TECHNICAL SERVICE BULLETIN

Accelerated Wear Of The Rear Inner Brake Pads Or Scraping And Grinding Noises

26-2274

Ford 2021-2026 Next-Generation Ranger

Figure 1 - Brake pad friction material thickness measurement with a gauge

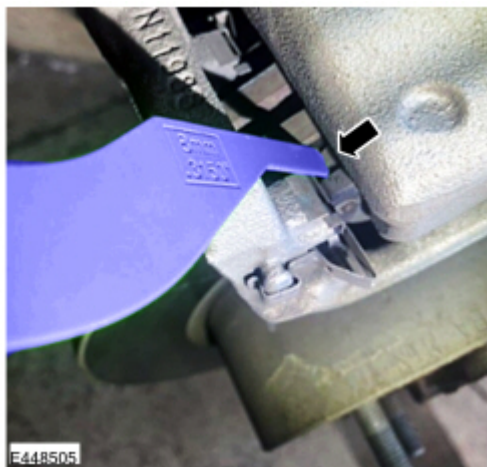
6. Remove the rear wheels. Refer to WSM Section 204-04.**7. Measure the rear brake pad friction material thickness on the inner and outer brake pads on the Right Hand (RH) and Left Hand (LH) side. (Figure 1)**

Figure 2 – this TSB applies. The wear difference is more then 3mm and the inner pad is worn out

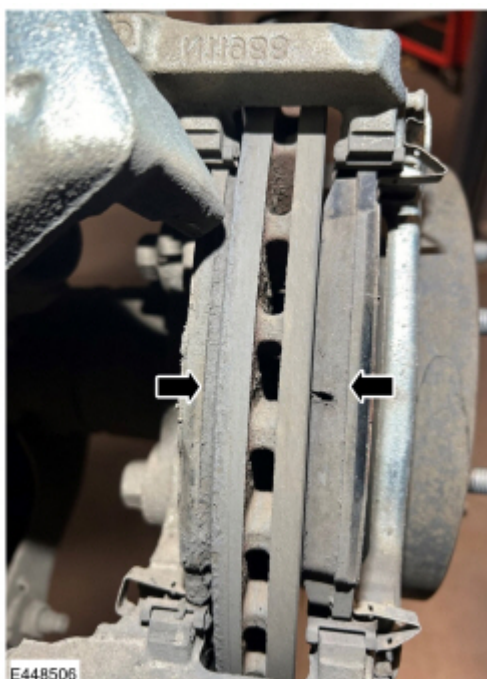
8. Is the inner and outer brake pad thickness difference 3mm or greater on the RH or LH side AND any pad thickness 1.5mm or less?

- (1). Yes – proceed to Step 9.
- (2). No - the pads are within specification. Refer to the WSM for normal diagnosis/repair.
